NATIVE VILLAGE OF EKLUTNA

April 9, 2024

RE: NVE Response to Draft Final Eklutna Fish and Wildlife Program

Pump Station Alternative – Project Description

FIGURE 2 – PUMP STATION ALTERNATIVE ENLARGED VIEW NEAR CYLINDER PUMP STATION

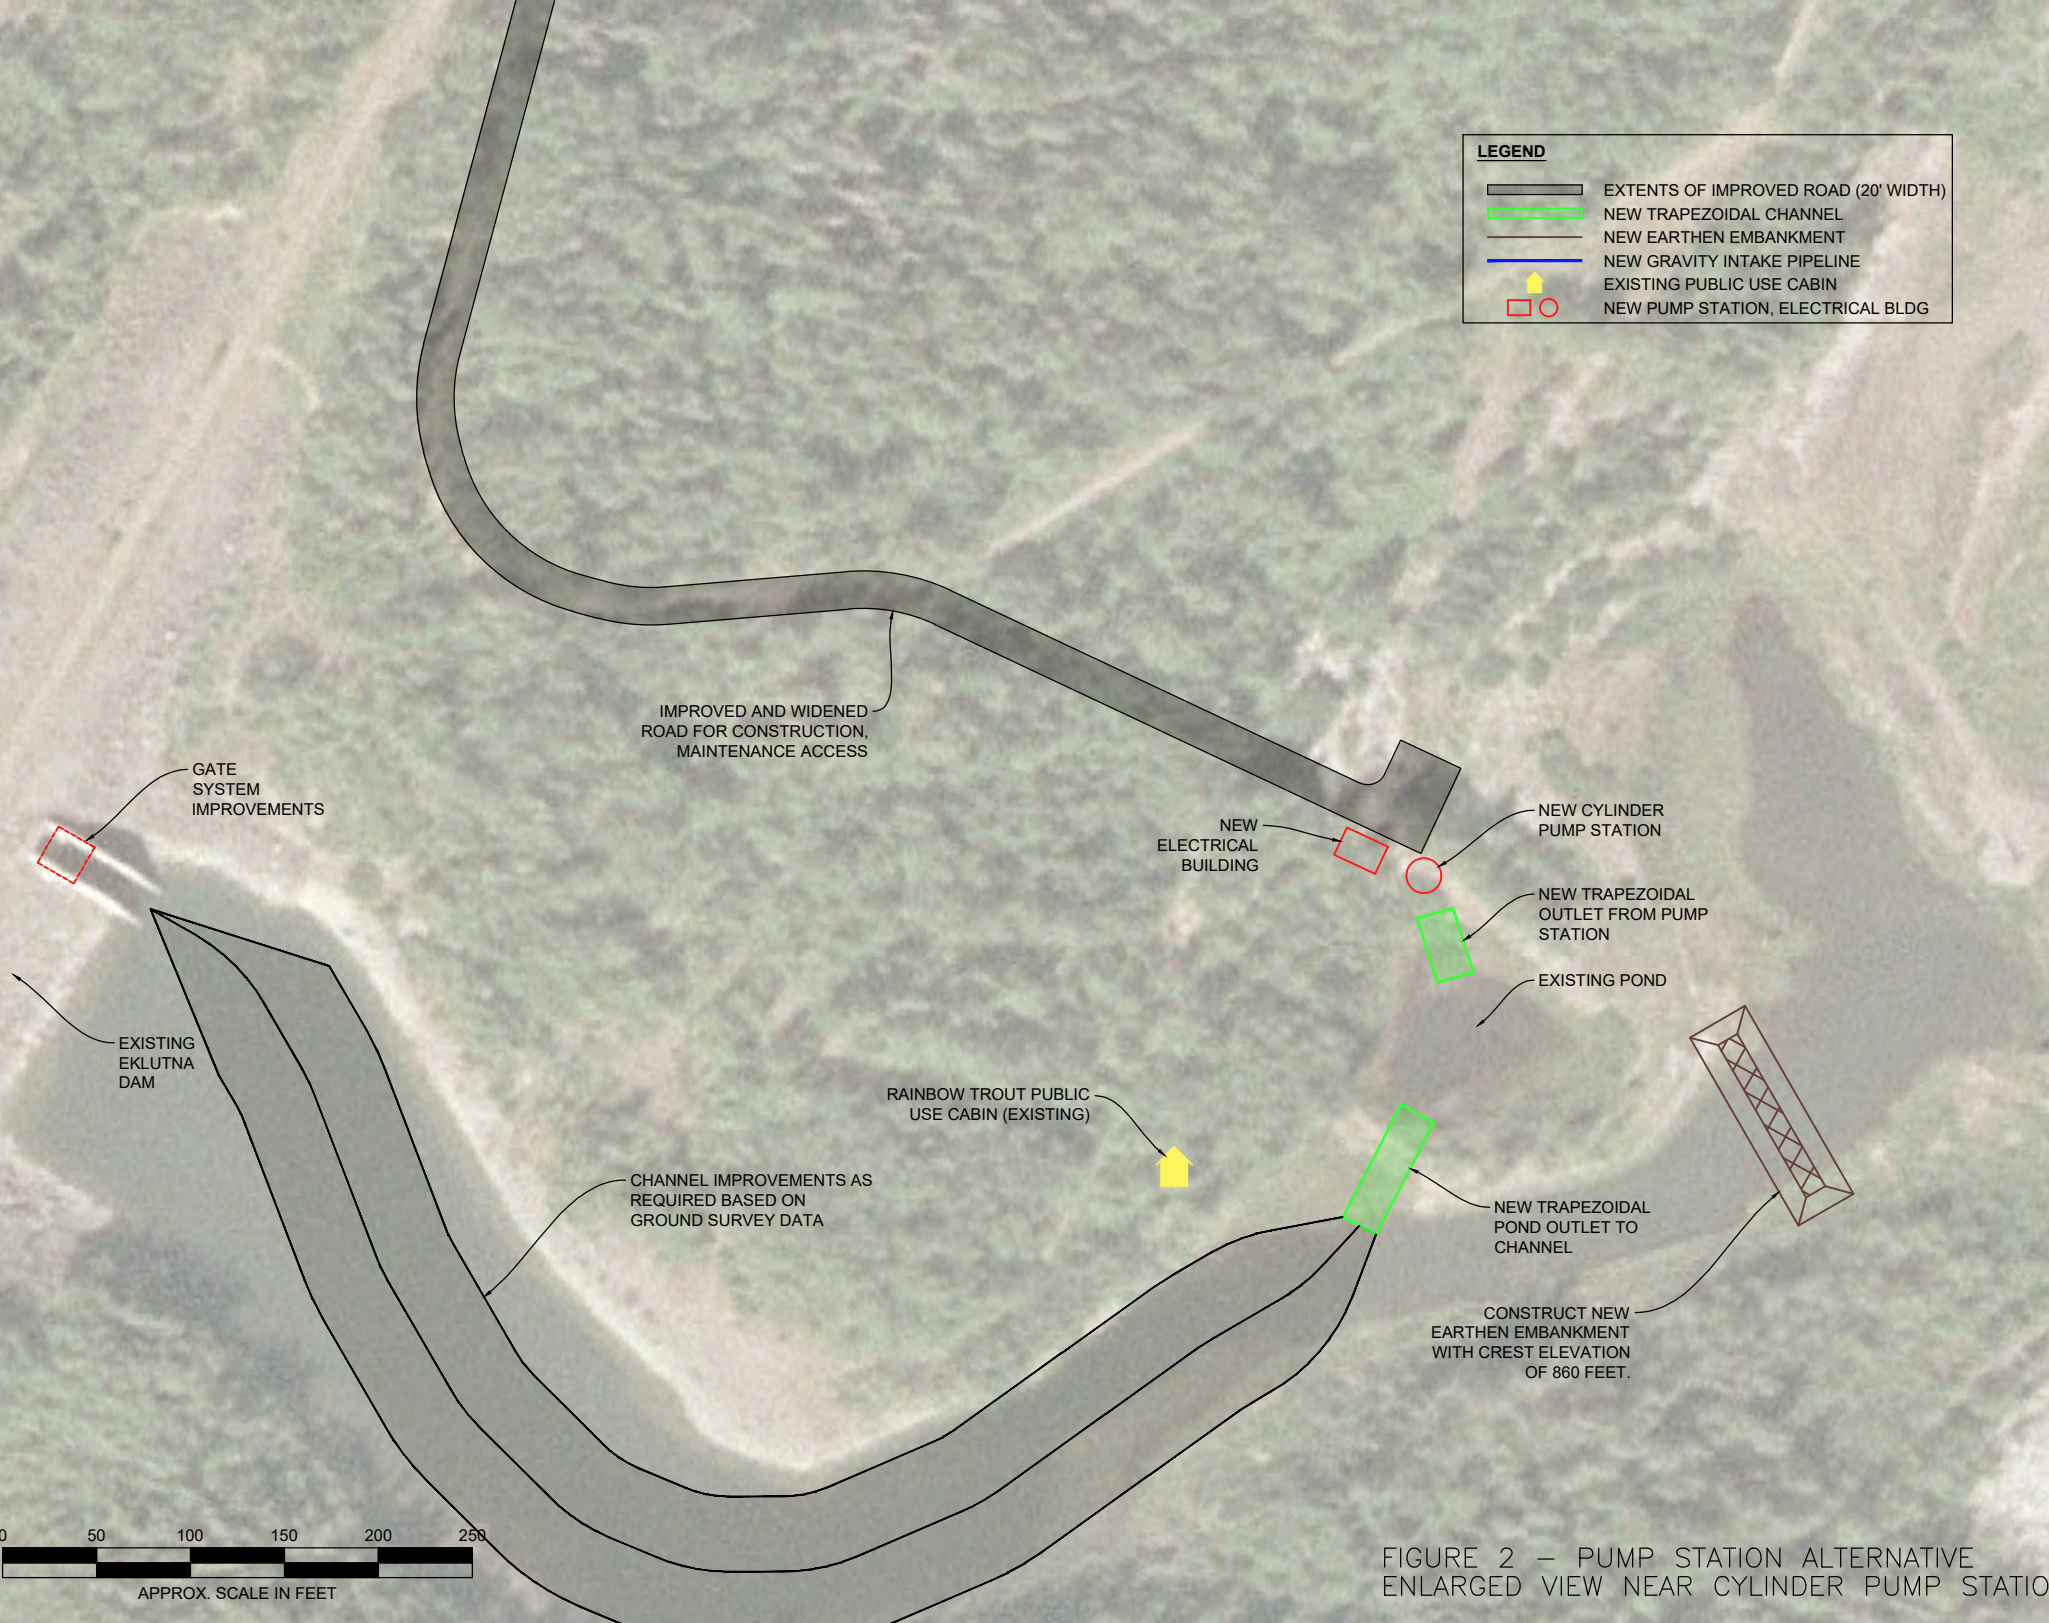
- Depth of Pump Station. The cylinder pump station must be low enough to allow gravity supply with Lake water at low lake level yet high enough to allow personnel and equipment access into the cylinder from the grade above (see Figure 2 for an enlarged view). The pump station bottom Elevation 800 is set based on a 0.1 to 0.125 slope of the raw water pipe from the Intake Crib. The pump station top Elevation 880 is set based on the existing grade near the pump station location. The bottom portion of the pump station cylinder should be constructed during the low water level time of year (May and June) up to perhaps Elevation 840 to 850. The top portion of the cylinder pump station can be constructed later in the summer but should be constructed such that Lake water does not overtop the top of wall at any time. The pump station should be a reinforced concrete cylindrical structure. See Figures 3 and 4 for details of the Cylinder Pump Station.

A 20-foot wide, gravel or asphalt, access road should be constructed for construction needs as well as later operations and maintenance needs. The road will be at approximate elevation 880. The routing should match the alignment of existing trails so as to disturb as few trees as necessary. A preliminary routing of the road is shown on Figures 1 and 2. This routing overlaps existing trails as much as possible

FIGURE 3 – PLAN VIEW OF CYLINDER PUMP STATION

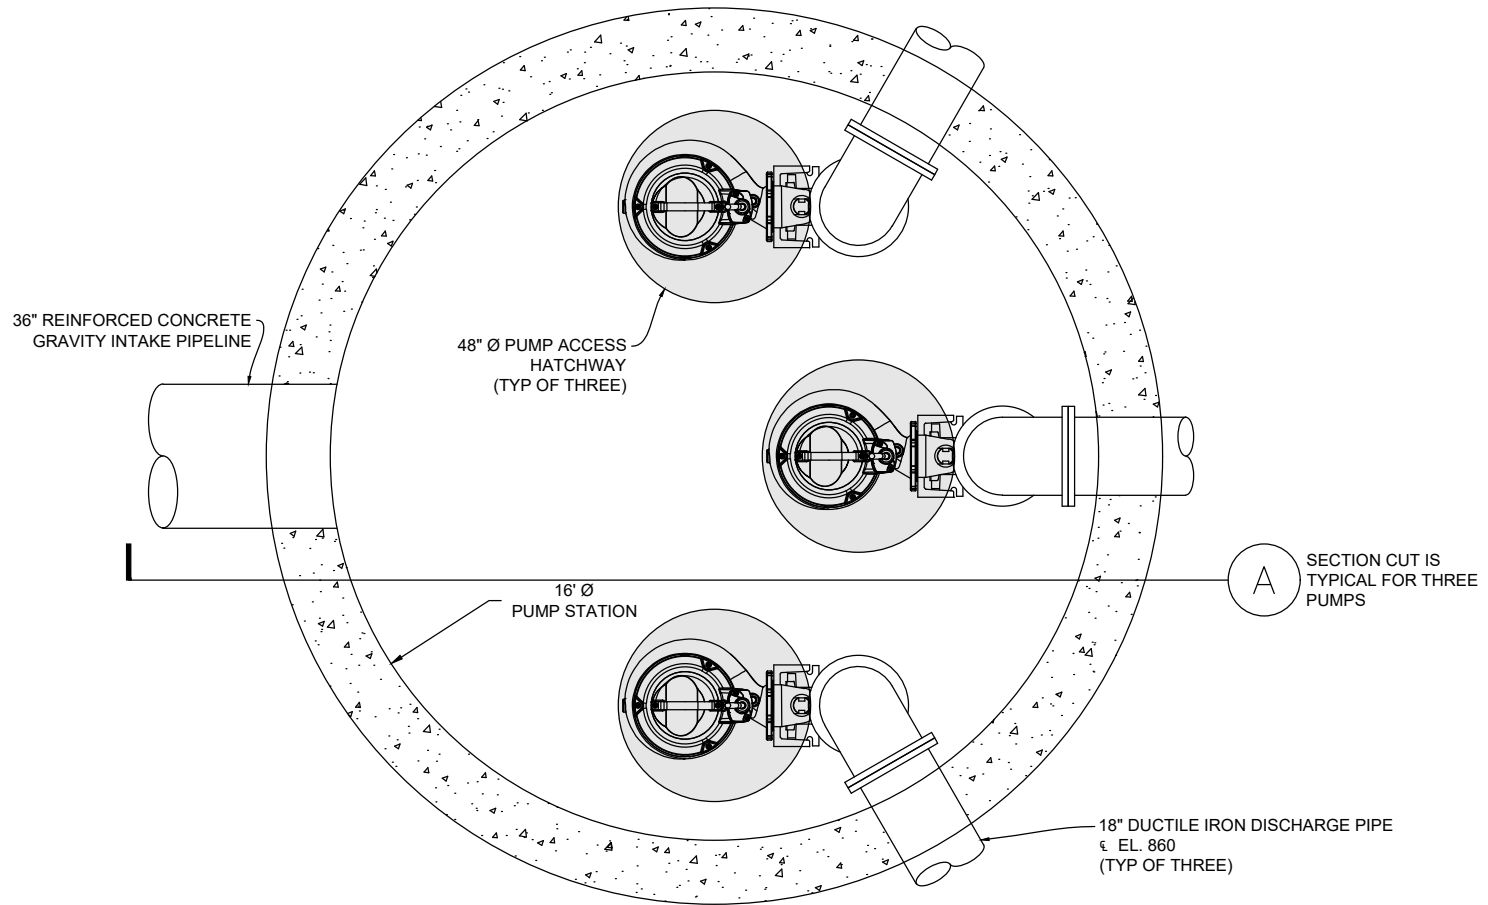
- Type/Size of Pumps. Three wet pit submersible pumps should be used as shown on Figure 3. Each pump should be rated 6,000 gallons per minute at a discharge head of approximately 45 feet (from low water surface elevation of 820 to the discharge elevation

FIGURE 5 – PRELIMINARY ELECTRICAL SINGLE LINE DIAGRAM

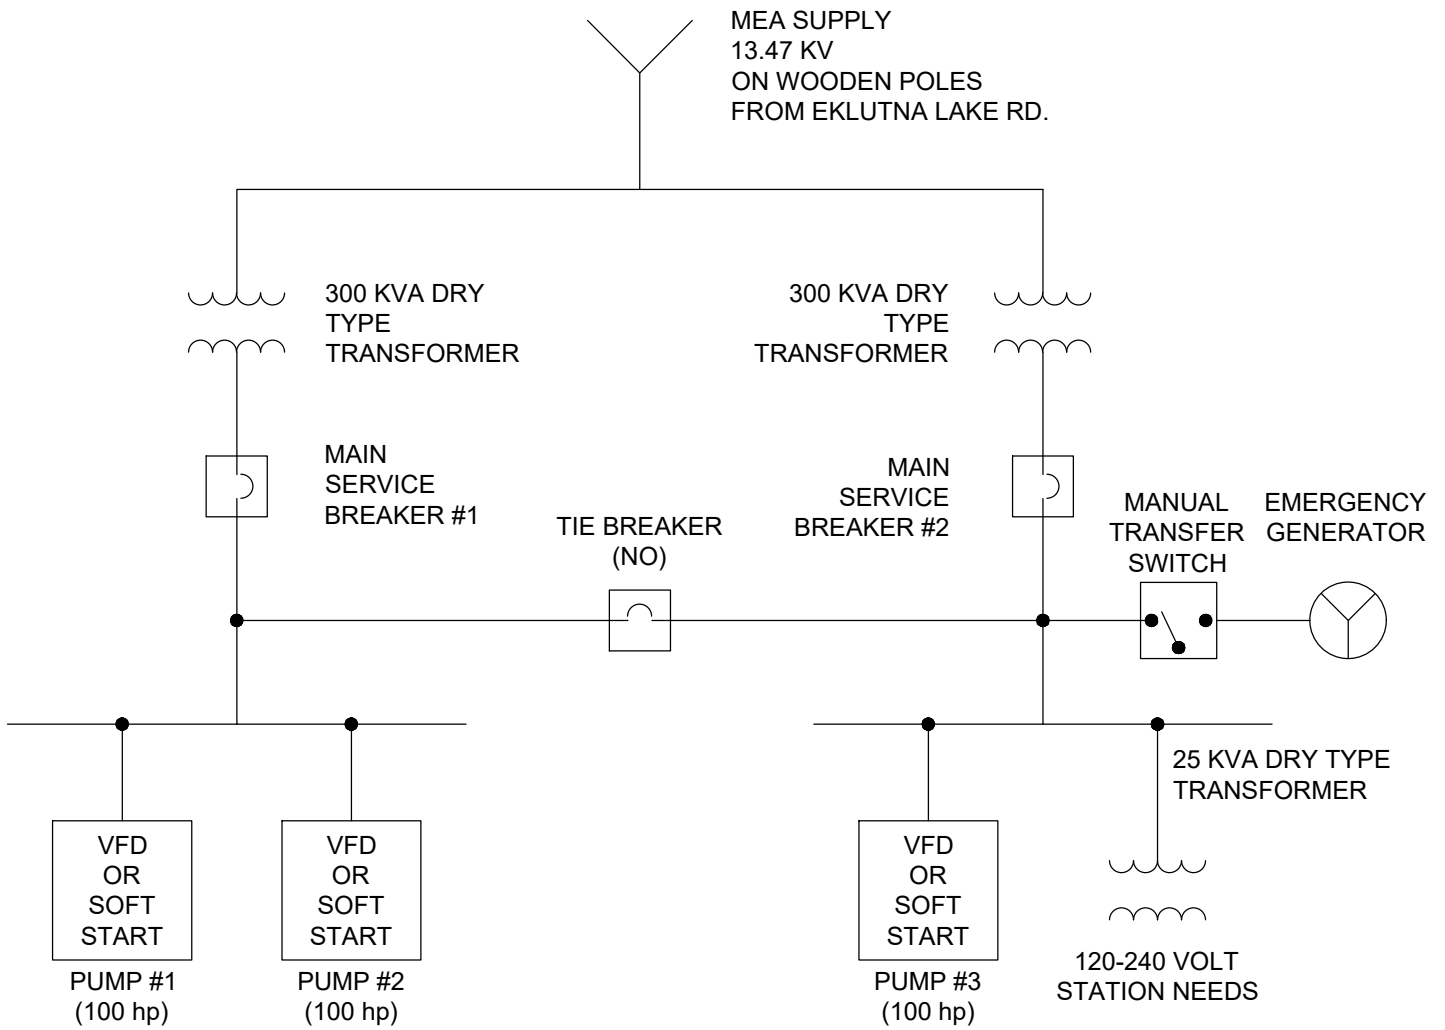
single phase station and grounds needs. Each pump should be powered with 480 volt Variable Frequency Drives or, at a minimum, with solid state soft starters to limit starting current in-rush. In addition, a manual transfer switch to connect a portable generator to the station should be provided in case of long-term power outages. It is anticipated that the Electrical Building would measure approximately 16 feet by 20 feet and that the building would be of CMU construction with a steel joist and metal deck roof. A preliminary electrical single line diagram is presented as Figure 5.
